Contract #: 04-0120F4Cty: SF/ALA Rte: 80 PM: 13.2/13.9File #: 69.25B

QUALITY ASSURANCE -- NON-CONFORMANCE REPORT

Location: Changxing Island, Shanghai, P.R. China**Report No:** NCR-000929**Prime Contractor:** American Bridge/Fluor Enterprises, a JV**Date:** 04-Dec-2010**Submitting Contractor:** Zhenhua Port Machinery Company, Ltd (ZPMC), Changxing Island**NCR #:** ZPMC-0891**Type of problem:**

Job Name: SAS Superstructure
Document No: 05.03.06-000887

Description of Non-Conformance:

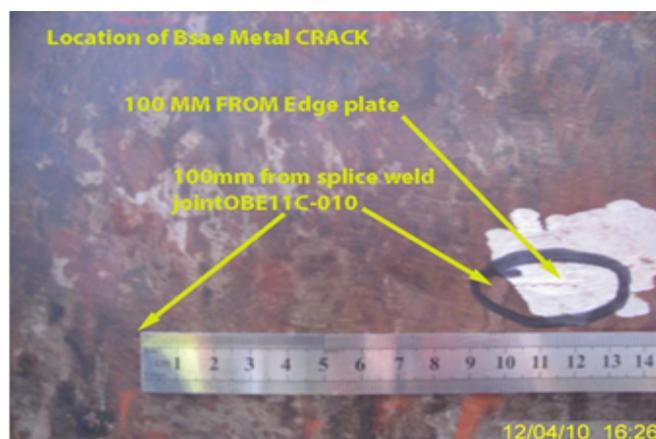
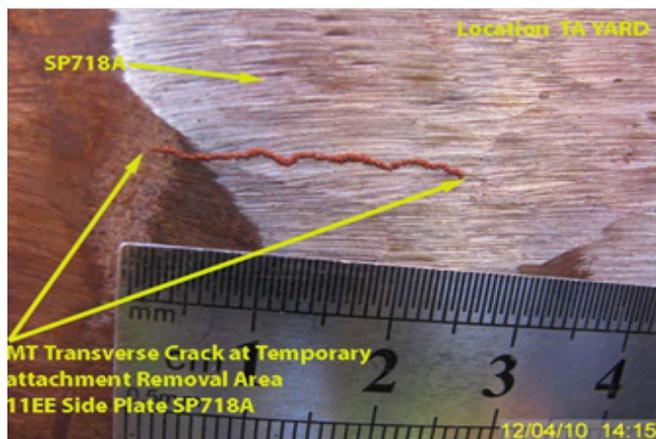
During the Quality Assurance (QA) Magnetic Particle Testing (MT) review of welds Temporary attachment Removal Area located on Orthotropic Box Girder (OBG) 11DE/11EE Transverse Splice Joint, this QA Inspector discovered the following issues:

- One transverse crack was found at the base metal after the removal of the temporary attachment. It is located near the Transverse Splice Weld Joint OBE11C-010 (joining 11DE/11EE).
- The affected side plate identified as SP718A (Segment 11EE).
- Base metal crack length measured approximately = 25mm.
- Y location = 100mm from the Transverse Splice Weld Joint OBE11C-010; 100mm from Edge Plate.
- The indication is clearly marked on the material.
- OBG 11DE/11EE is located at the trial assembly area.
- The Notice of Witness Inspection Number (NWIT) is 07619.

-This weld (base metal repair) is within an area previously tested and accepted by ABF Quality Control (QC) personnel. ABF's QC personnel are required to perform 100% MT inspection.

Contractor will repair the defective area, and provide NDT report to prove the repairs are acceptable. ZPMC will identify the inspector involved, issue an internal NCR and monitor his work. Disciplinary action will be taken if the inspector misses indications continuously.

Contractor repaired the defects, and provided the NDT report to prove the repairs are acceptable. The inspector involved has been identified and his performance is being monitored.

Description of Non-Conformance:

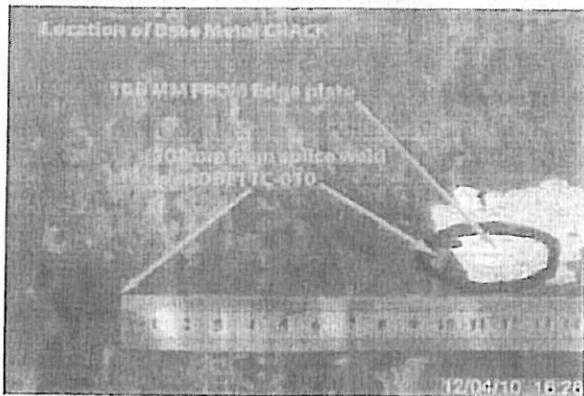
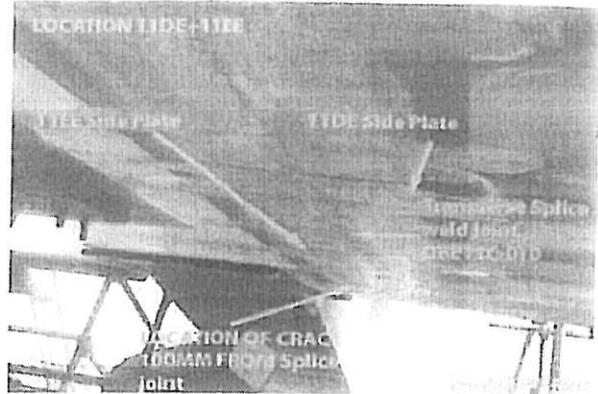
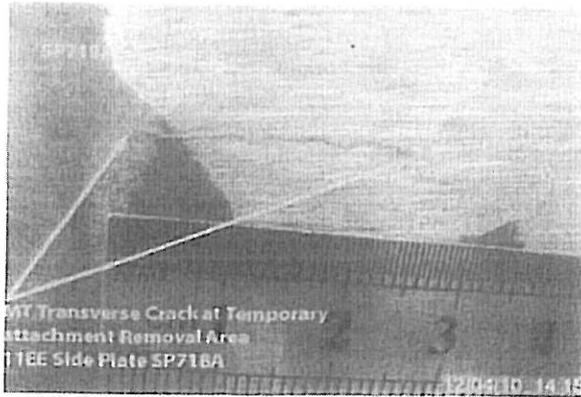
During the Quality Assurance (QA) Magnetic Particle Testing (MT) review of welds Temporary attachment Removal Area located on Orthotropic Box Girder (OBG) 11DE/11EE Transverse Splice Joint, this QA Inspector discovered the following issues:

- One transverse crack was found at the base metal after the removal of the temporary attachment. It is located near the Transverse Splice Weld Joint OBE11C-010 (joining 11DE/11EE).
- The affected side plate identified as SP718A (Segment 11EE).
- Base metal crack length measured approximately = 25mm.
- Y location = 100mm from the Transverse Splice Weld Joint OBE11C-010; 100mm from Edge Plate.
- The indication is clearly marked on the material.
- OBG 11DE/11EE is located at the trial assembly area.
- The Notice of Witness Inspection Number (NWIT) is 07619.

-This weld (base metal repair) is within an area previously tested and accepted by ABF Quality Control (QC) personnel. ABF's QC personnel are required to perform 100% MT inspection.
